**PROPOSED UPGRADES TO INTERSTATE  
STANDBY PARKING LOT AT THE PORT OF  
GALILEE PROJECT  
316 GREAT ISLAND ROAD  
VILLAGE OF GALILEE  
NARRAGANSETT, RHODE ISLAND 02882**

**NOTICE TO PROSPECTIVE BIDDERS**

ADDENDUM NO. 1      Prospective bidders and all concerned are hereby notified of the following changes in the Plans, Specifications, Proposal and Distribution of Quantities for this contract. These changes shall be incorporated in the plans, specifications, Proposal and Distribution of Quantities, and shall become an integral part of the Contract Documents.

ADDENDUM NO. 1

SHEET NO.  
2  
(R-1)

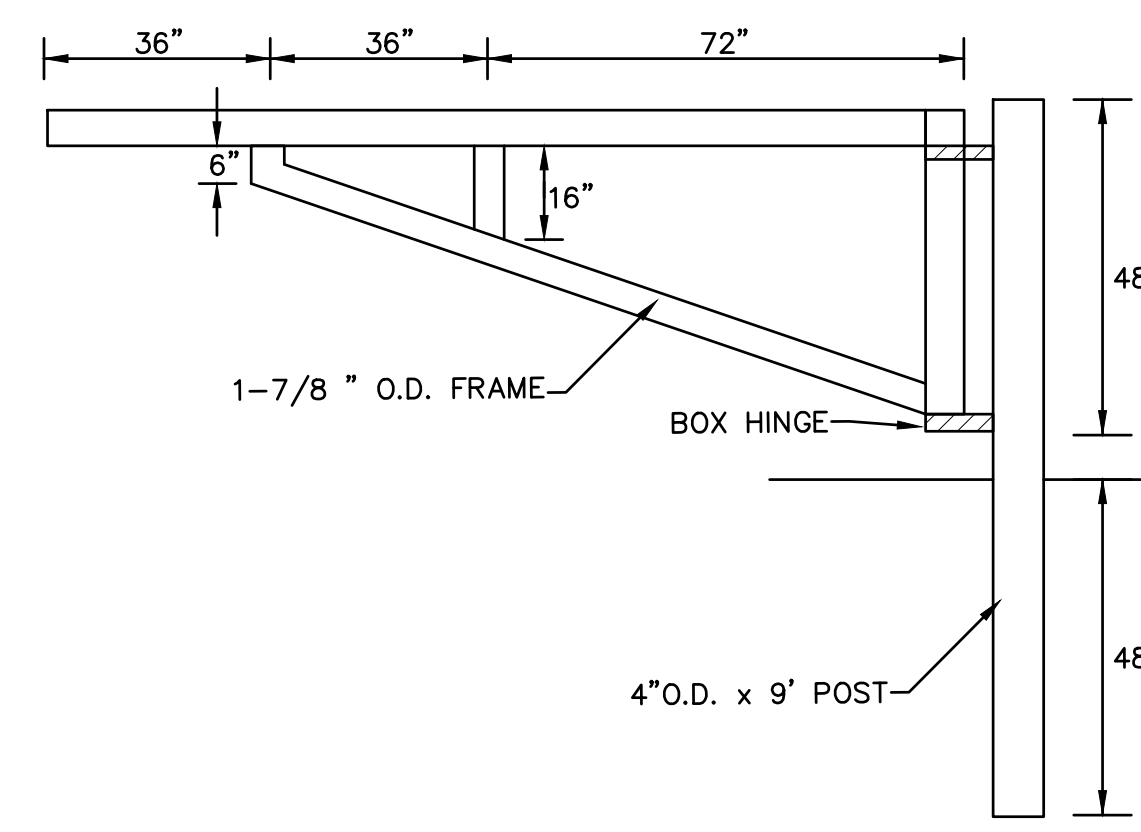
*(Added Engineer's stamp to Drawing Sheets 1, 2 and 3); Revised Grading Plan, limits of work, and the Owner's responsibility)*

Drawing (Sheet 2)

Delete Drawing (Sheet 2) in its entirety and replace it with Drawing (Sheet 2) (R-1)

SHEET NO.  
3  
(R-1)

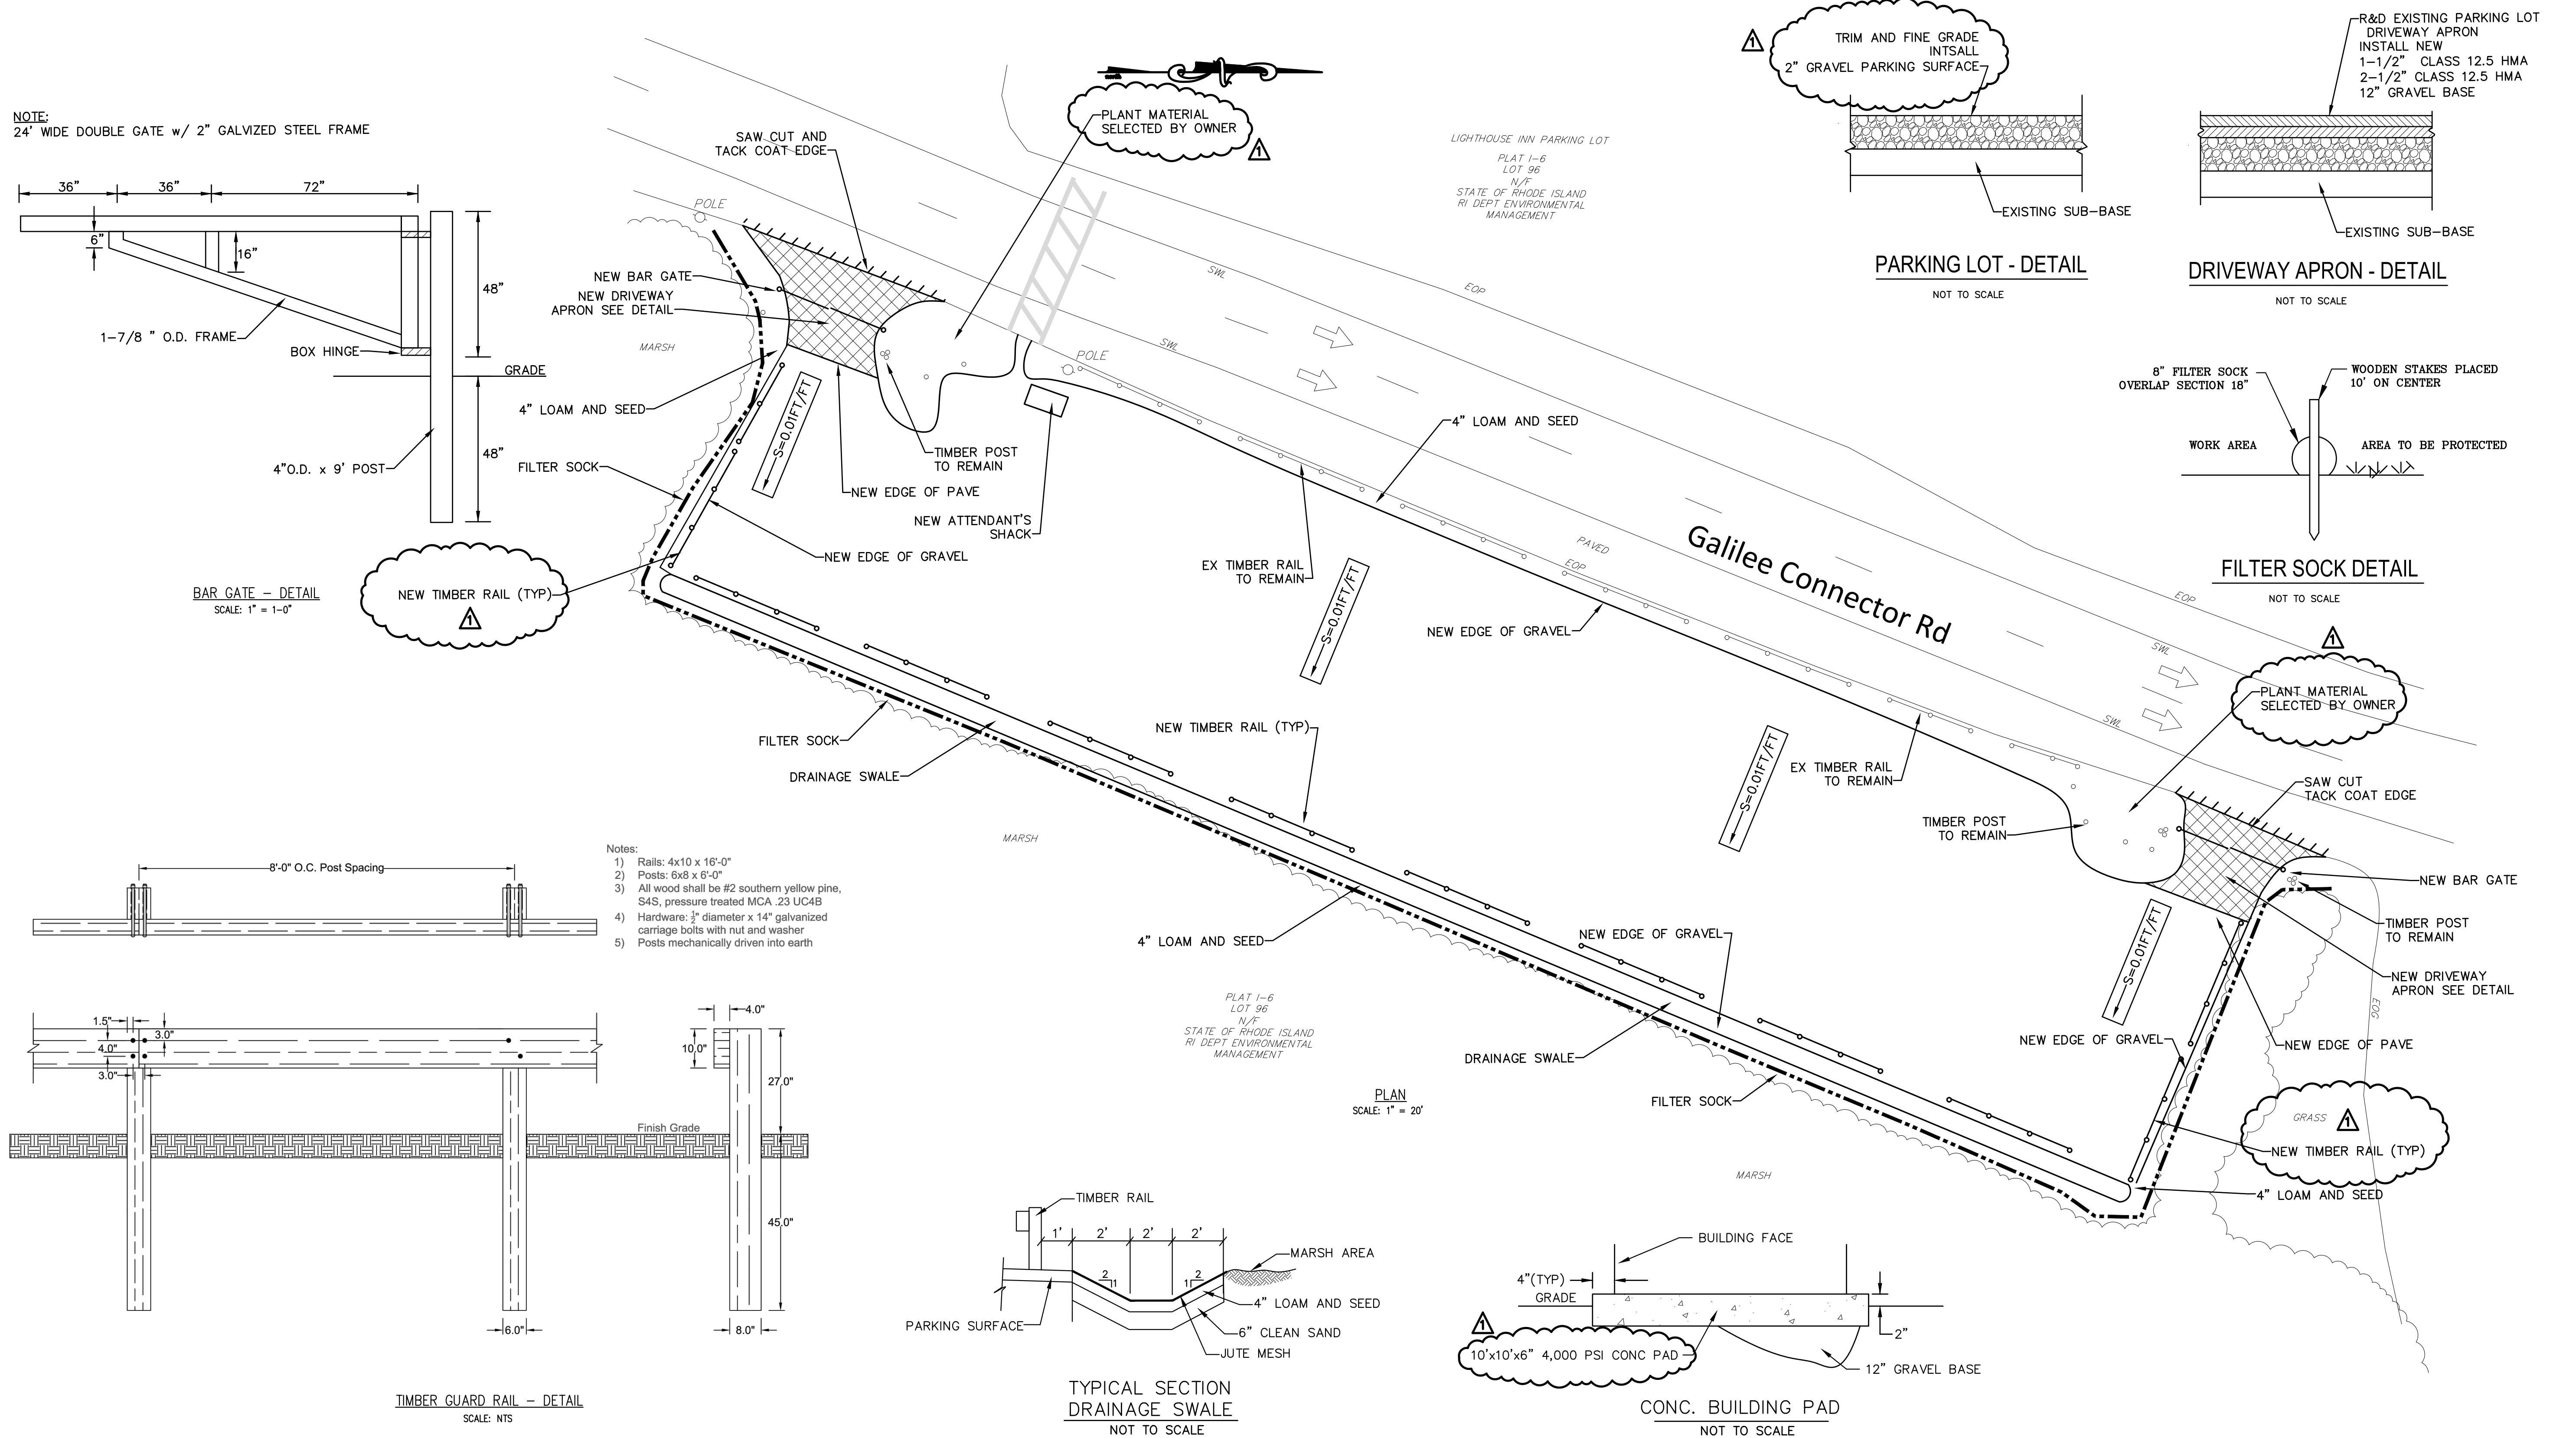
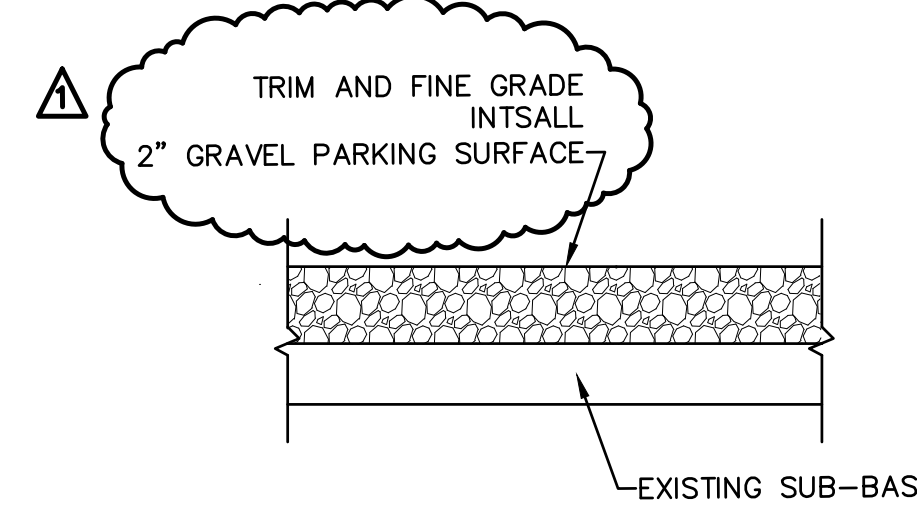
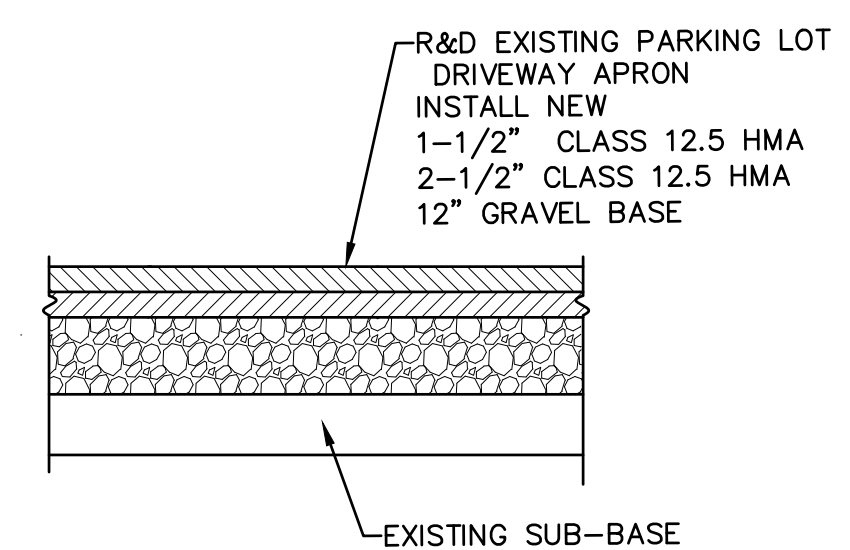
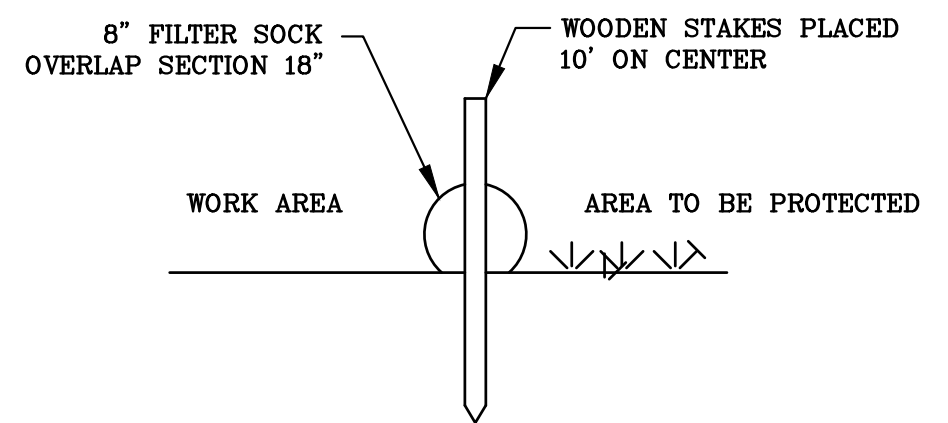
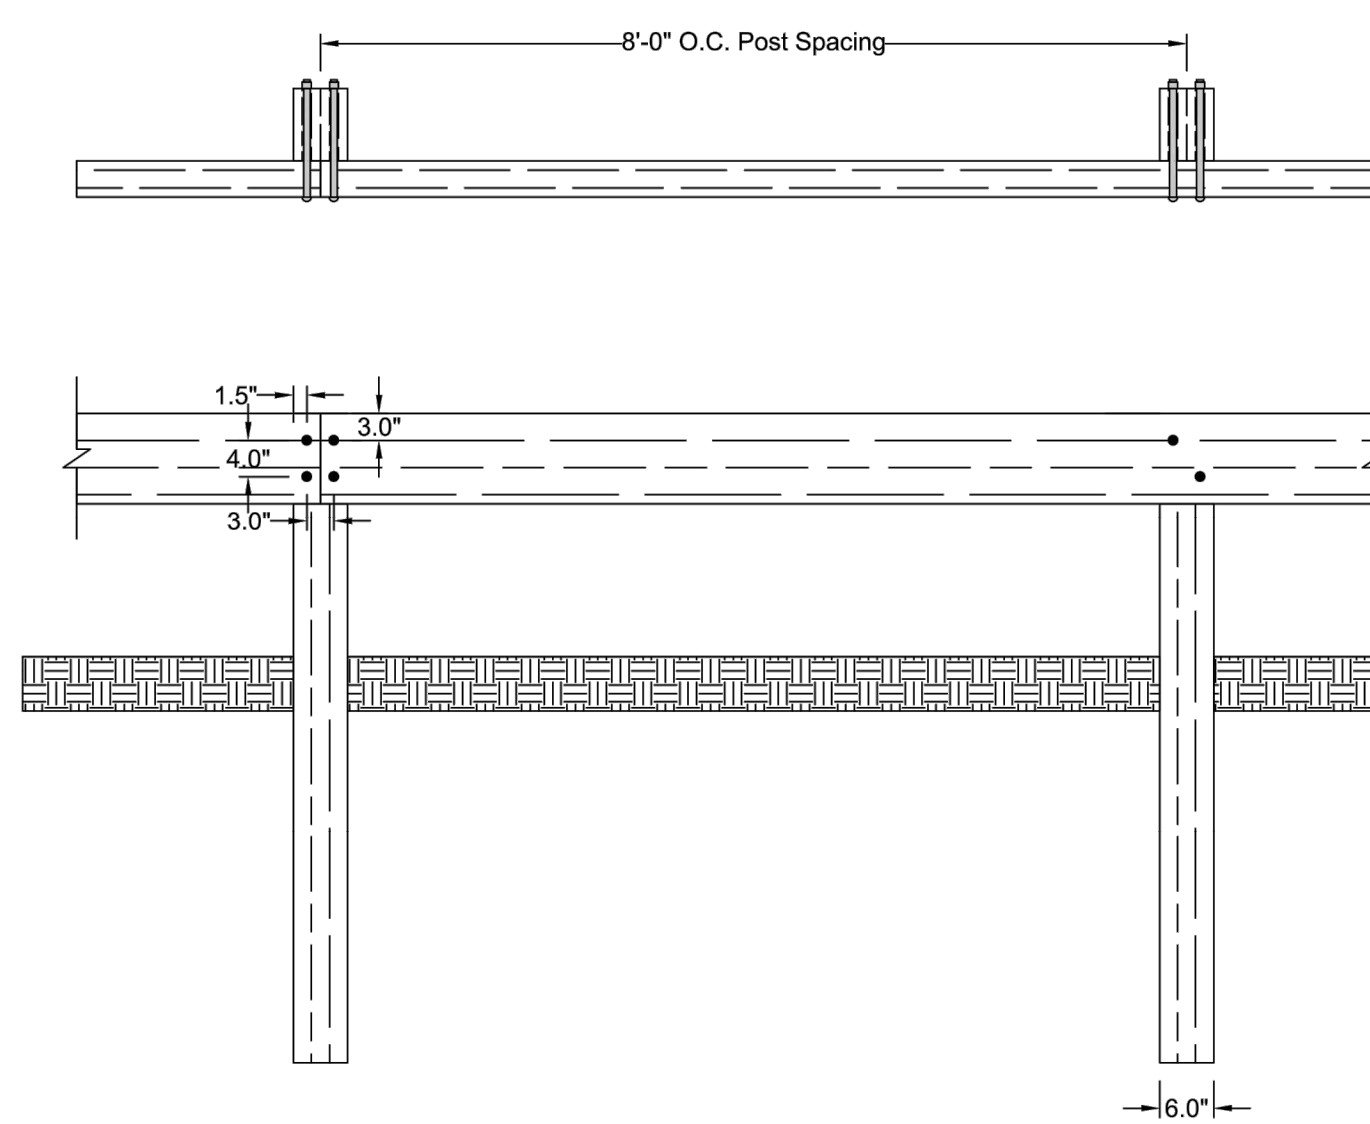
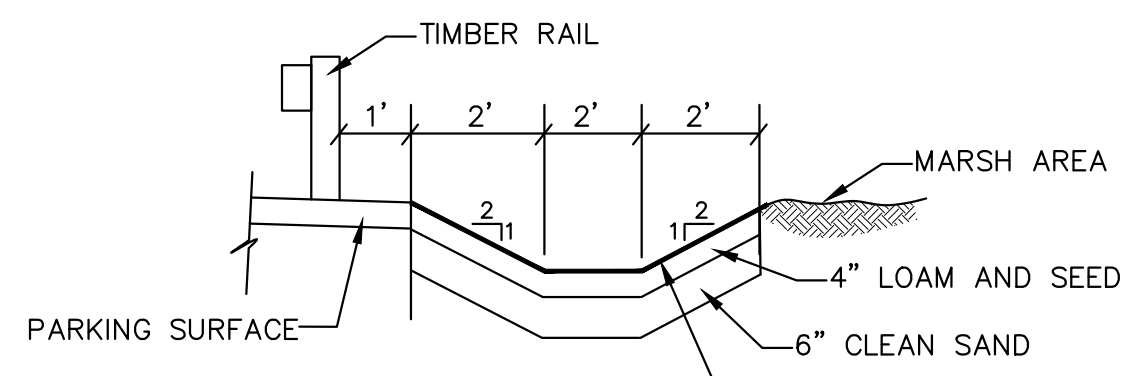
Drawing (Sheet 3)

Delete Drawing (Sheet 3) in its entirety and replace it with Drawing (Sheet 3) (R-1)
